## Response to: Annex L - Shadow Flicker and Blade Glint Assessment for the Proposed Jupiter Wind Farm

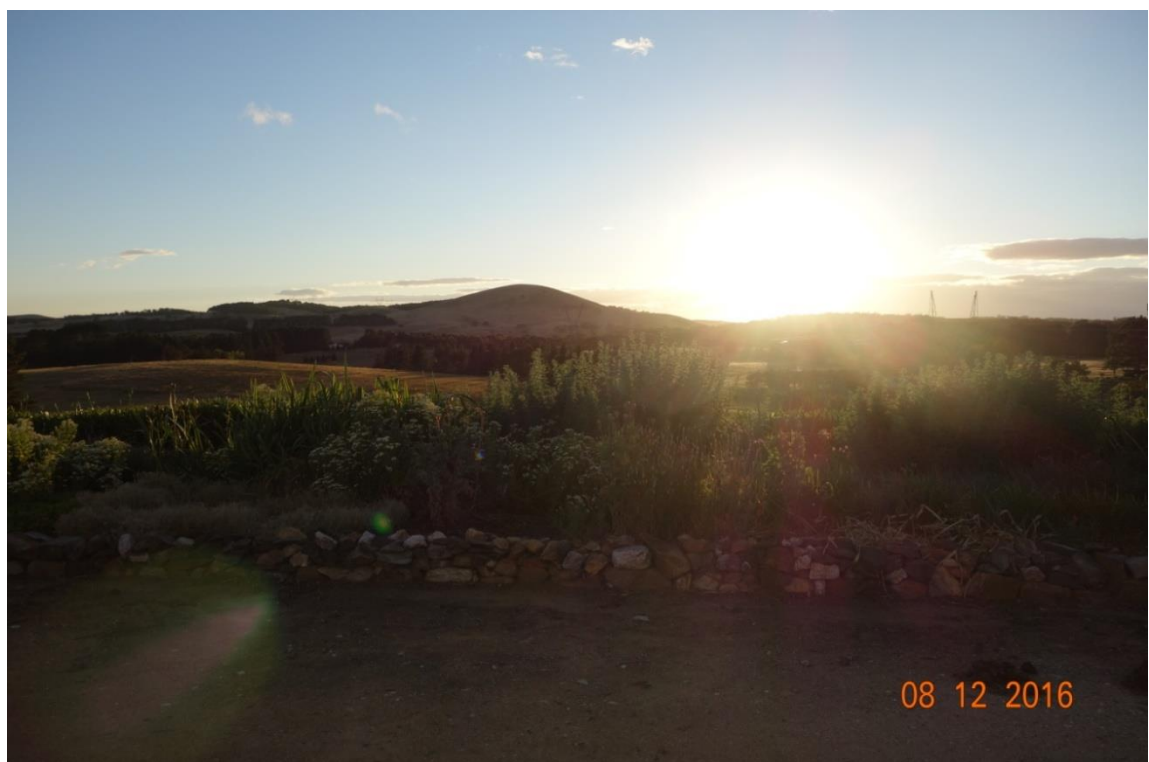
**Shadow Flicker:** The montage of Mt Fairy Road at Annex F : Landscape & Visual Impact Assessment Report S14-0147 Issue H Private Receptor Viewpoint 14 pp 88 shows turbines in the distance to the right hand side of Mount Fairy Trig Point.

This is where the sun rises for several months over Summer for residents along and adjacent to Mt Fairy Road. The following picture is my view. My household (and my 2 neighbours) were not included in the EPYC submission even though we were part of the 2011 census.

This picture is self explanatory. If we can see as many turbines as we are led to believe from the less than specific information that we have been provided with from Jupiter, then you can see that the sun is going to be shining through the blades towards us every morning and all we (and our neighbours) will see is flickering. At present we have no flickering. **How does Jupiter plan to alleviate this?**
